# ADDENDUM # 1

## North Ward Park – FB18184

December 18, 2017

**MODEL 493 SM**  
 SHOWN W/ OPTIONAL SS SURFACE CARRIER

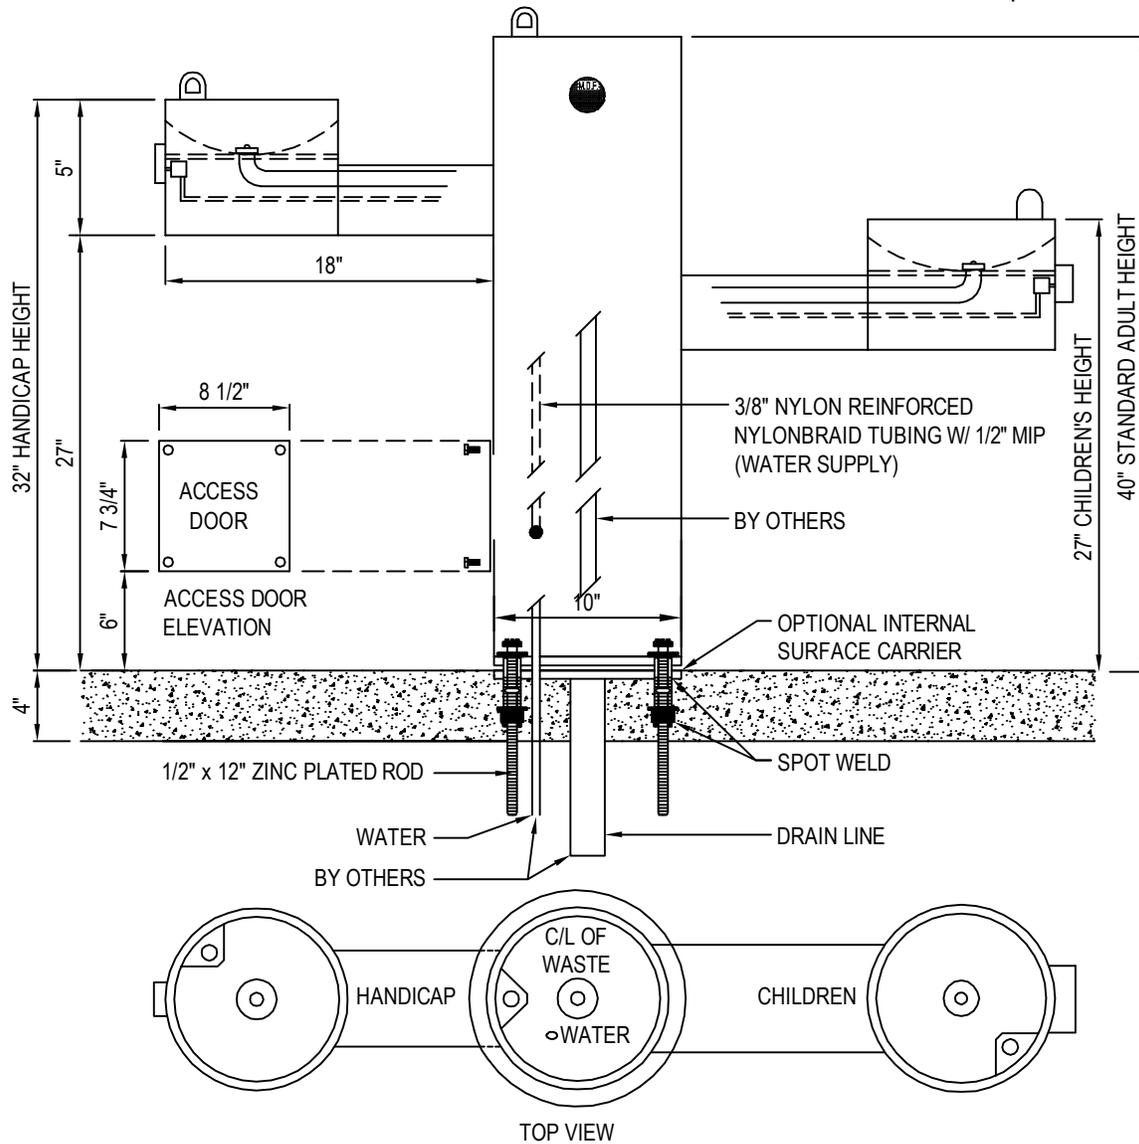
**Answer:** Three (3) drinking fountains shall be added to this bid. The drinking fountains, or approved equal, shall be per: Most Dependable Fountains; Model # 493 SM, color: Blue, per attached cut sheet.

- a. Fountain "A" shall be located at the rear corner of parking area & corner near the playground. A 3/4" tee shall be installed on main 1-1/2" line to serve drinking fountain "A".
- b. Fountain "B" shall be located off a 1" line between bathrooms and spray pad (specific location to be determined in the field). A 1" tee shall be installed on the main 1-1/2" line at the corner of the sidewalk and restrooms and a 1" line shall run parallel to the sidewalk on the east side to the corner of the restroom sidewalk at sidewalk stub to spraypad, where a 3/4" stub shall be placed to serve the shower. **The existing / proposed shower connection (as shown on sheets SP-15 & 16) to the equipment room shall be eliminated.**
- c. Fountain "C" shall be located near the shelter on a 3/4" line running from the end of the 1" line at the sidewalk stub to spraypad.

- 7. In addition, pipe material for fountains A, B, C & shower to be new type "K" soft copper.**
